# 15 SUB2007-00187

## **ESCHOL PLACE SUBDIVISION**

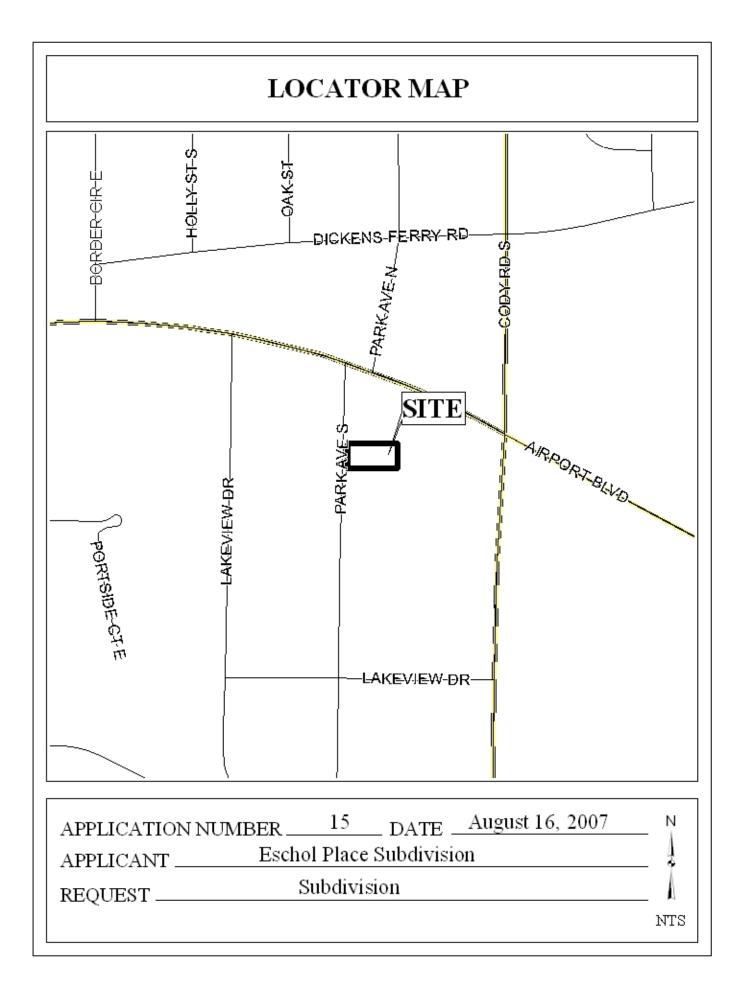
The site fronts Park Avenue South, which has an adequate 50' right-of-way. No building setback line is indicated on the plat; therefore, a 25' minimum building setback line along the Park Avenue South frontage should be depicted on the final plat. A note should also be placed on the final plat limiting the subdivision to one curb cut to Park Avenue South, with the size, location, and design to be approved by the Mobile County Engineering Department.

No lot sizes in square feet were indicated on the plat; therefore the final plat should be revised to label each lot with its size in square feet, or a table depicting the same information should be provided.

The property is located in the County; thus a note should be required on the final plat stating that any lots that are developed commercially and adjoin residentially developed property must provide a buffer, in compliance with Section V.A.7. of the Subdivision Regulations.

The site is in the unincorporated part of Mobile County; nevertheless, development should be designed to comply with the stormwater detention and drainage facilities of the City of Mobile stormwater and flood control ordinances. Submission of certification from a licensed engineer certifying that the design complies with the stormwater detention and drainage facilities of the City of Mobile stormwater and flood control ordinances prior to the issuance of any permits

- 1) depiction of the 25' minimum building setback line along Park Avenue South;
- 2) placement of a note on the final plat stating that the subdivision is limited to one curb cut to Park Avenue South, with the size, location, and design to be approved by the Mobile County Engineering Department;

- 3) the labeling of each lot to indicate its size in square feet, or provision of a table on the plat with the same information;
- 4) the placement of a note on the final plat stating that any lots that are developed commercially and adjoin residentially developed property must provide a buffer, in compliance with Section V.A.7. of the Subdivision Regulations; and

- 5) placement of a note on the Final Plat stating that development will be designed to comply with the stormwater detention and drainage facilities of the City of Mobile stormwater and flood control ordinances, and requiring submission of certification from a licensed engineer certifying that the design complies with the stormwater detention and drainage facilities of the City of Mobile stormwater and flood control ordinances prior to the issuance of any permits. Certification to be submitted to the Planning Section of Urban Development and County Engineering.
